Modification Recommended Service Note

Supersedes:
N4694D-02

N4694D Electronic Calibration Module (ECal)

Serial Numbers: MY57450000- MY59410001

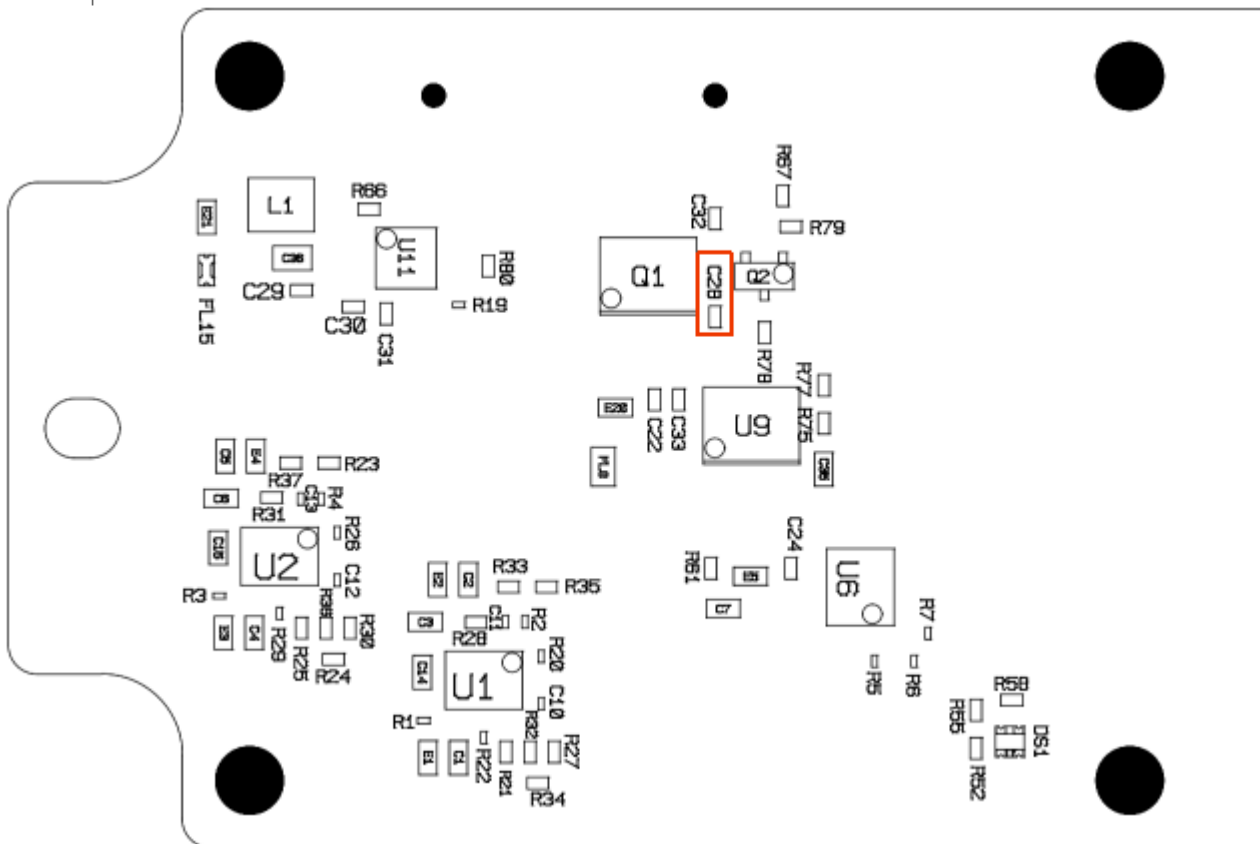
The Problem – A resonance can develop in the heater circuit which can cause an RF tone between 140 MHz and 150 MHz to be injected onto the signal path.

The heater circuit in the N469xD ECal modules was initially designed with a dampening capacitor. It was found in a small number of ECal modules that a resonance can develop in this circuit after the modules is warmed up. This resonance can cause an RF tone between 140 MHz and 150 MHz to be injected onto the signal path.

The dampening capacitor was eliminated in all ECal modules with serial prefix MY5941 and above.

Open the ECal module and remove the N4690-63004 printed circuit board. On this board, locate the C28 capacitor indicated here:

If this capacitor has been removed, no further action is required. Reassemble the ECal module.

If this capacitor exists on this board, this capacitor should be carefully unsoldered and removed, or the N4690-63004 printed circuit assembly should be replaced. Once this is done, reassemble the ECal module.
